Report Title	M5 Junction 14 and A38 / B4509 Signalised Junction Stage 1 Road Safety Audit Response Report
Date	2 nd September 2020
Document reference and revision	39209_5570_TN002
Prepared by	Stantec
On behalf of	Highways England and South Gloucestershire Council

Job Name: West of Park Farm, Thornbury
Job No: 39209
Note No: 5570_TN002
Date: 2 September 2020
Prepared By: K. Stock
Subject: **Road Safety Audit Response Report – M5 Junction 14 and A38/B4509 Signalised Junction**

Road Safety Audit Stage 1

TMS reference no: 15667
Date: 23rd June 2020

Please refer to the following page for a plan illustrating the locations of the problems identified as part of this audit (location numbers refer to paragraph numbers in the report).

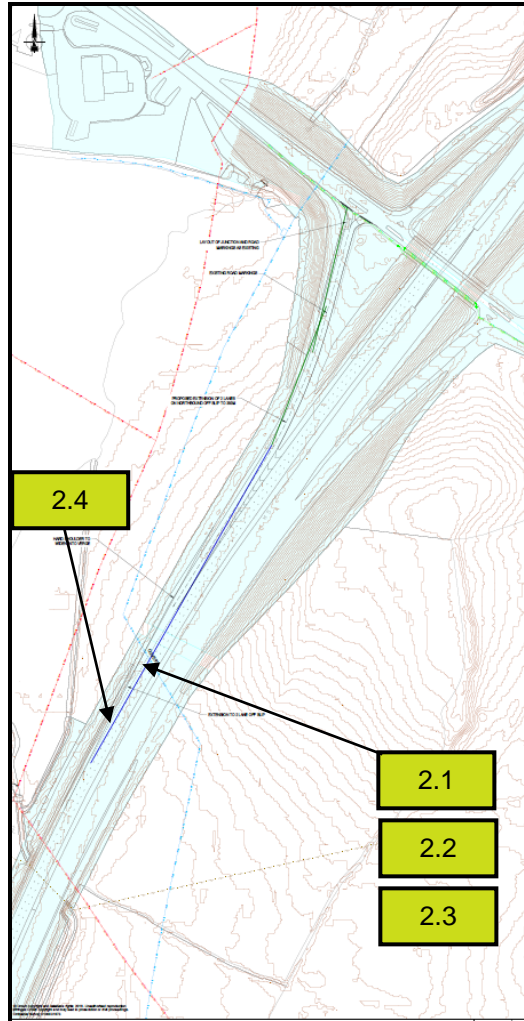
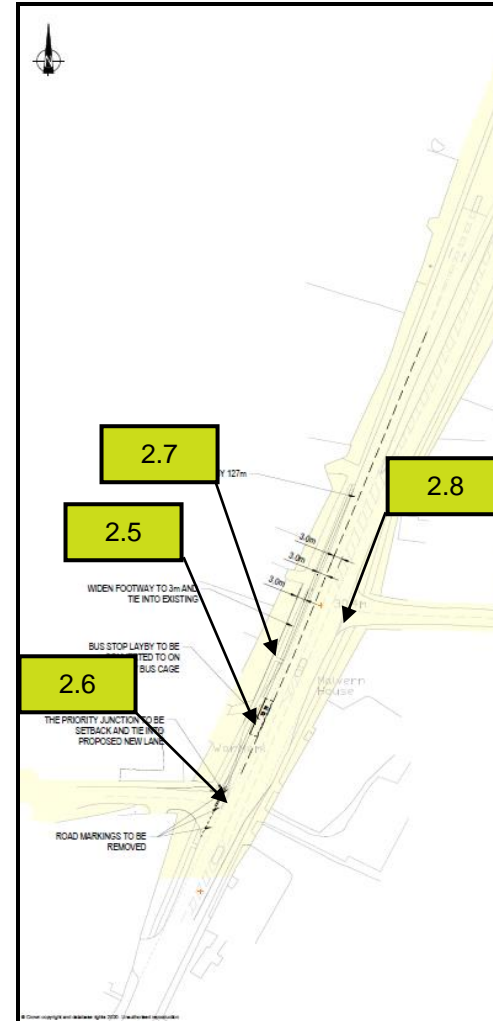
2.1 PROBLEM

Summary: Speed related collisions on slip lane

With the proposed two-lane extension for the motorway off slip, this will create a longer potentially at grade section of slip lane, where at quieter times of the day, vehicles might be able to carry more speed when heading off the motorway, with little deflection. This could increase the risk of speed related collisions such as shunt collisions and overshoots at the give way priority junction with the B4509.

2.2 PROBLEM

Summary: Lane swapping side swipes at diverge

The existing priority junction layout, where the off slip joins the B4509 is proposed to be retained, where the two lanes on the off slip are for left or right turners only, meaning that drivers will have to ensure they get into the correct lane early at the diverge point. With the extended two-lane layout and not knowing any detailed dimensions at this stage, the diverge taper might not be insufficient, reducing the window for drivers to react and this could increase the risk of late braking and side swipe collisions.

2.3 PROBLEM

Summary: Lane swapping side swipes on the off-slip lane

From Google street view there is currently no signing to tell drivers which lane they should be in at the B4509 junction, other than arrow markings indicating left or right only close to the junction, where they have little time to react, which could result in side swipe collisions. With the longer off slip lanes proposed there might also be more temptation to swap lanes (not knowing the status of the lanes) and then trying to cut in late near to the junction, increasing the risk of shunt collisions with following traffic.

2.4 PROBLEM

Summary: Strike hazard with trees at diverge

Several trees are currently located at the new proposed diverge taper, where the risk of collision could be higher at this point with lane changing/ weaving vehicles. If an errant vehicle does leave the carriageway following a collision or a late manoeuvre, they could be at an increased risk of a high-speed impacts with the trees.

2.5 PROBLEM

Summary: Lane swapping collisions

With the bus stop layby proposed to be removed and for busses to stop on the main carriageway instead, when a bus is stopped to pick up or drop off passengers it will block the straight ahead lane, where vehicles will then have to overtake in the right turn lane only, This could increase the risk of side swipe collisions and late manoeuvres close to the junction when they realise they are in the incorrect lane.

2.6 PROBLEM

Summary: Pull out collisions at side road

The point at where the northbound single lane starts to filter into two lanes for straight ahead and right turn only is very close to the junction of Sundayshill Lane, where northbound vehicles may start to filter early at the junction. For drivers turning out of the junction they might not see other vehicle commencing overtakes to head into the right filter lane, where they could be masked by vehicles in the 'straight ahead' lane and pull out in front of them, increasing the risk of collisions occurring.

2.7 PROBLEM

Summary: Collisions with pedestrians at uncontrolled crossing point

At this uncontrolled crossing point, on the west side pedestrians will now have to cross two lanes of traffic instead of one and this is close to the point where the A38 will filter into two lanes. There will be an increased distance to cross, with potentially unpredictable lane changing traffic, which could increase the risk of pedestrian collisions with oncoming vehicles.

2.8 PROBLEM

Summary: Turning collisions with oncoming vehicles

With the potential increase traffic flows and additional right turners on the A38 at the junction with Mill Lane, this could make it difficult for drivers wanting to turn right out of Mill Lane; where there is potentially two lanes of queuing traffic to negotiate. Drivers might choose to creep out and block the southbound lane on the A38, increasing the risk of collision with oncoming traffic.

Deflection measures should be introduced such as a ghost island diverge layout. The ramp gradient on the off-slip lane extension should also be reviewed at the detailed design stage and altered accordingly.

At detailed design stage the diverge taper length and nosing should be reviewed, ensuring they allow sufficient driver reaction time to manoeuvre into the correct lane, where a ghost island diverge lane layout should also be installed to assist drivers to enter the correct lane with greater time to react.

A ghost island diverge layout should be installed, with clear advance signing to indicate the two separated lanes for the B4509 East and B4509 West.

The Armco VRS should be extended to cover the diverge taper and surrounding area.

The bus stop should be relocated, or a new layby created if land is available.

The filter lane commencement should be start further north away from Sundayshill Lane junction.

The crossing point should be upgraded to a controlled crossing or the crossing point should be relocated.

'Keep Clear' road markings should be installed on the two northbound lanes to allow for the passage of right tuners from Mill Lane.

Client
**BARWOOD
 DEVELOPMENT
 SECURITIES**
 Date of 1st Issue 08.11.19
 A1 Scale 1:500
 Drawing Number **39209/5501/SK31**

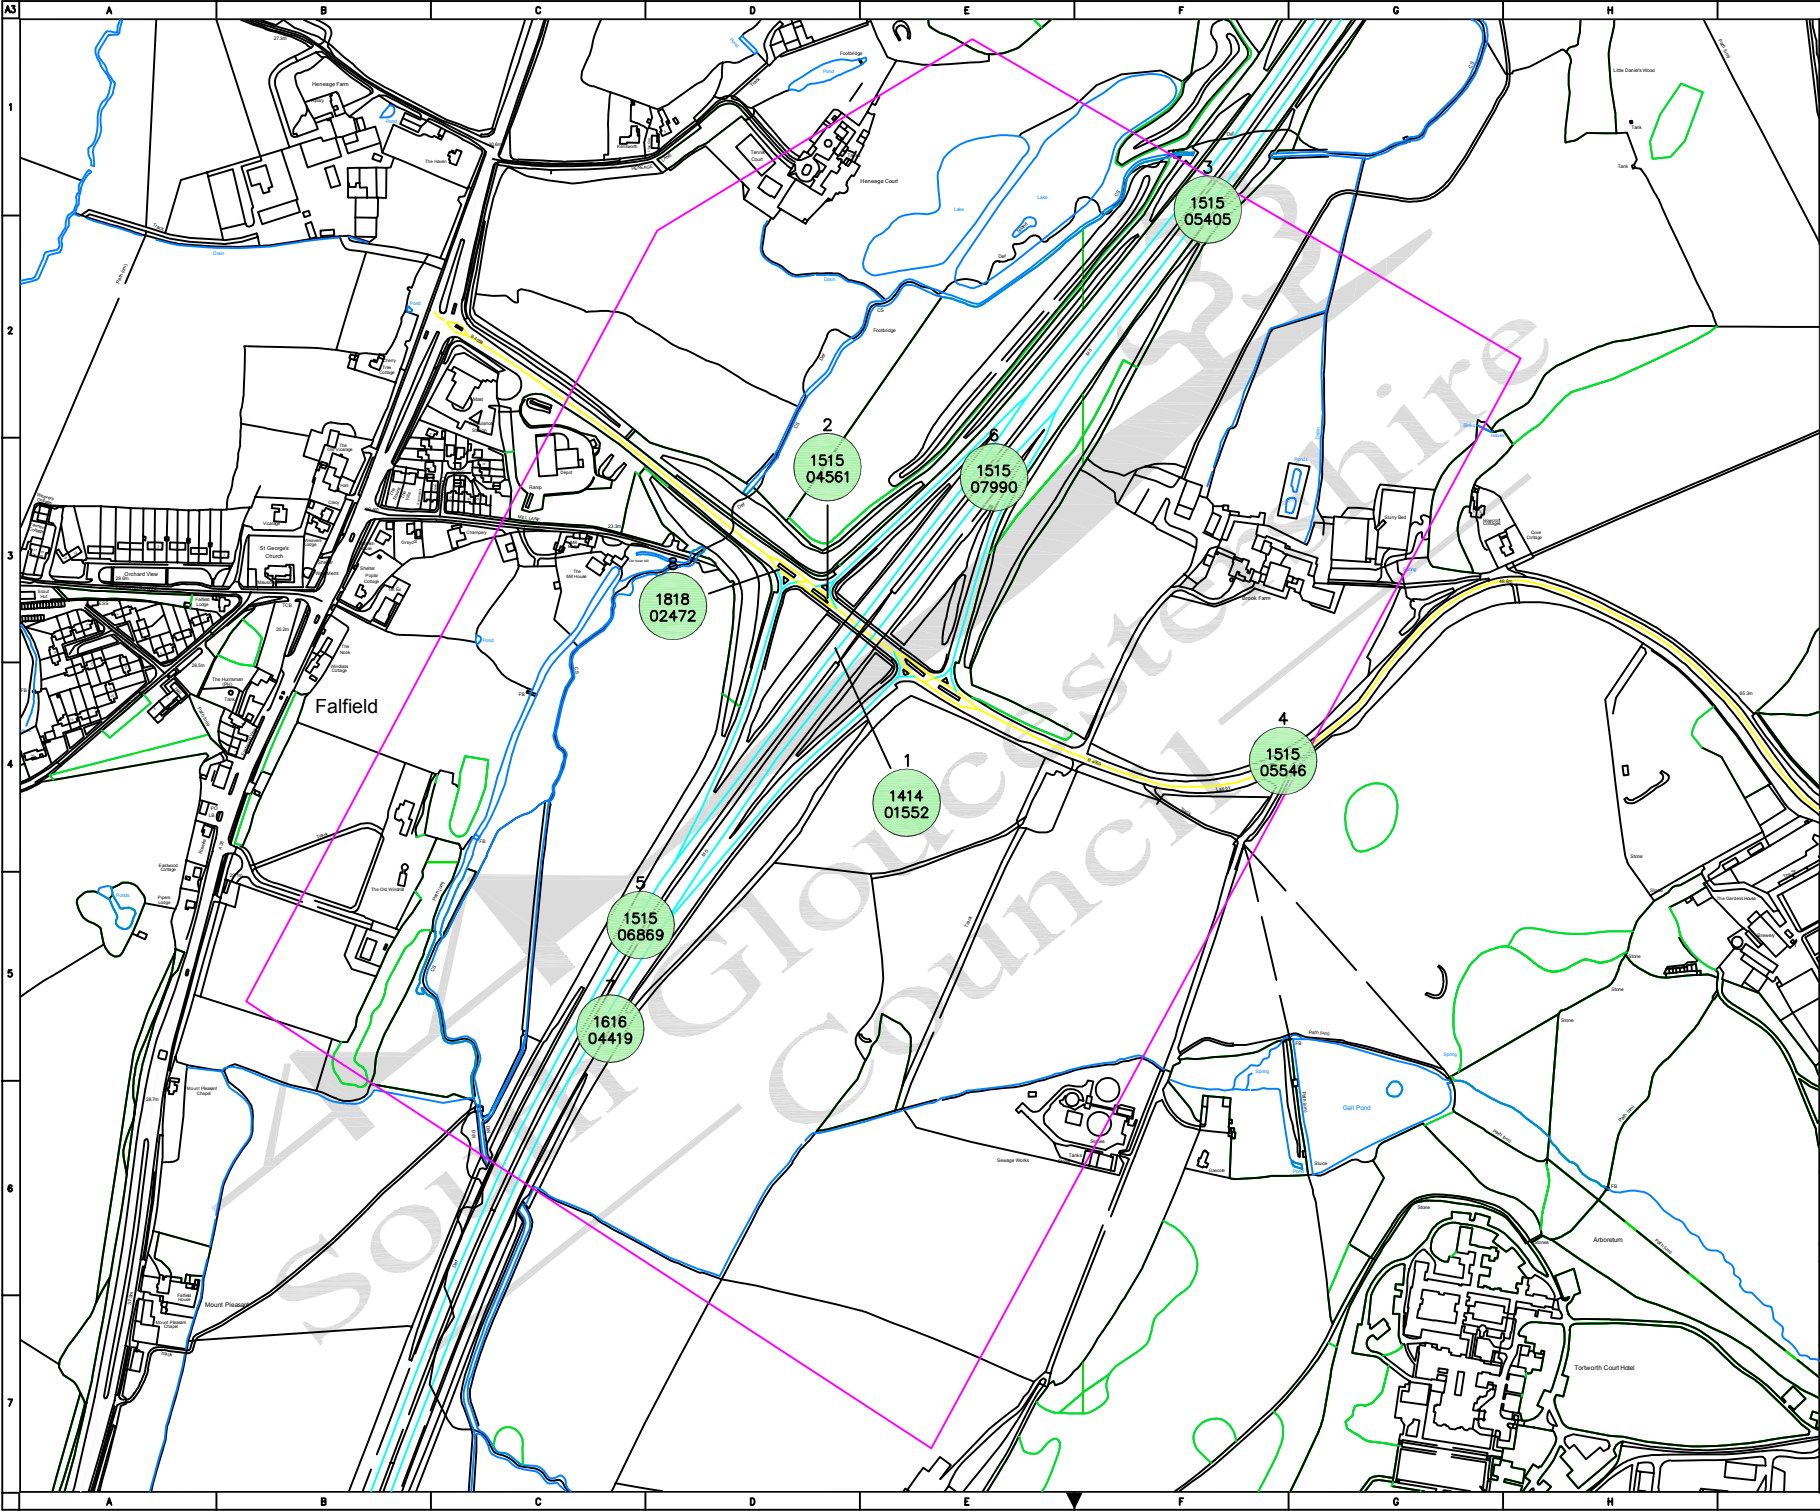
2.1	According to the Road Safety Audit, there is the possibility that vehicles might be able to carry more speed when leaving the motorway, with little deflection. It goes on to say that this would increase the risk of speed related collisions such as shunt collisions and overshoots at the give way priority junction with the B4509.	4	2	8	There is no evidence of existing collisions of this nature.	4	2	8	<p>Junction with B4509 is unchanged within proposed highway scheme.</p> <p>Ramp gradient to be developed at detailed design stage.</p> <p>No change from safety baseline.</p>

2.2	According to the Road Safety Audit, there is a risk that drivers will have to ensure they get into the correct lane early at the diverge point due to the two lanes on the off slip are for left or right turners only. It also states that with the extended two-lane layout, the diverge taper might be insufficient, reducing the window for drivers to react and this could increase the risk of late braking and side swipe collisions.	4	2	8	<p>A ghost island diverge layout is not considered necessary for the reasons set out above.</p> <p>Signage/road marking directions can be reviewed at the detailed design stage to avoid propensity for weaving, such as left and right turn lane markings provided at the start of the two lanes to continue for the length of the slip road at intervals to be agreed.</p>	3	2	6	Signage design strategy to be developed at detailed design stage.

2.3	<p>According to the Road Safety Audit, there is a risk that lane swapping will result in side swipes on the off-slip lane.</p> <p>It goes on to states that there is currently no signing to tell drivers which lane they should be in at the B4509 junction, other than arrow markings indicating left or right only close to the junction, where they have little time to react.</p> <p>The RSA suggests that there may be more temptation to swap lanes and trying to cut in late near to the junction, increasing the risk of shunt collisions, and recommends a ghost island diverge layout should be installed, with clear advance signing to indicate the two separated lanes for the B4509 East and B4509 West.</p>	4	2	8	<p>A ghost island diverge layout is not considered necessary for the reasons set out above.</p> <p>Clear advance signing will be installed to indicate the two separated lanes for the B4509 East and B4509 West.</p>	3	2	6

2.4	According to the RSA there is a risk of collisions at the proposed diverge taper with lane changing / weaving vehicles, and an increased risk of high-speed impact with trees.	2	4	8	The Armco VRS will be extended to cover the diverge taper and surrounding area.	2	2	4

Ref	Hazard / Risk Description	L	S	R	Response / Control Measure	L	S	R	Details / assumptions / monitoring
	The RSA recommendation suggests that deflection measures should be introduced such as a ghost island diverge layout. The ramp gradient on the off-slip lane extension should also be reviewed at the detailed design stage and altered accordingly				<p>A ghost island diverge layout is not considered necessary and the design standard for a 'Two lane auxillary diverge' specifically allows the layout proposed for amendments to existing junctions (DMRB CD122 Layout B option 2). The mainline and connector road stopping sight distance visibility is considered appropriate, reducing the risk of shunt collisions and overshoots at the give way line.</p> <p>The ramp gradient on the off-slip lane extension will be reviewed at the detailed design stage and altered accordingly.</p>

Ref	Hazard / Risk Description	L	S	R	Response / Control Measure	L	S	R	Details / assumptions / monitoring
	The RSA recommendation suggests that at detailed design stage the diverge taper length and nosing will be reviewed, ensuring they allow sufficient driver reaction time to manoeuvre into the correct lane, where a ghost island diverge lane layout should also be installed to assist drivers to enter the correct lane with greater time to react.				Signage on the approach could also be provided; the exact locations are to be confirmed through the detailed design.
